COUNTY OF LOS ANGELES

DEPARTMENT OF PUBLIC WORKS

NOTICE TO BIDDERS "A"

MAGIC JOHNSON PARK MAKE READY AND PARKING PROJECT SPECS. NO. 7918; C.P. NO. 8A189

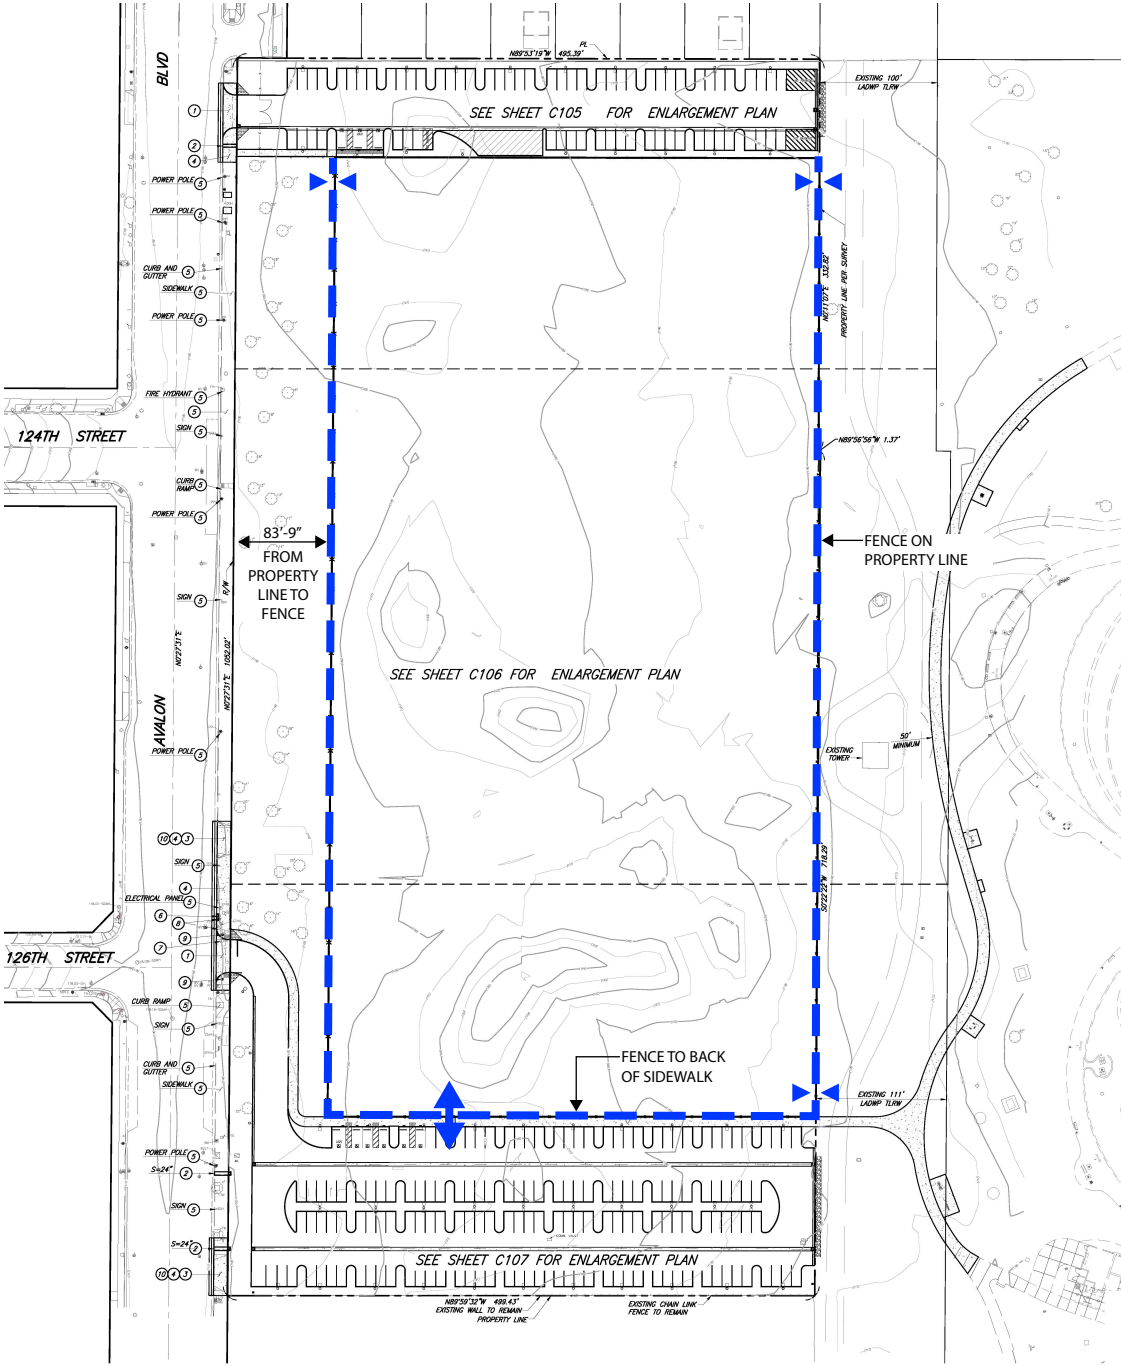
1. Refer to Street Improvements Plan portion of the plans. **Delete** in its entirety and **replace** with the attached revised Street Improvements Plan (Attachment 4).
2. Refer to Sheet C104.1. **Delete** in its entirety and **replace** with the attached Sheet C104.1 as Bid Alternate 1. (Attachment 5).

-  FENCING (BID ALTERNATE 1)
REFER TO SPECIFICATION SECTION 31 32 00
-  PEDESTRIAN GATE (3'-0" MIN.)
-  VEHICULAR GATE (12'-0" MIN.)
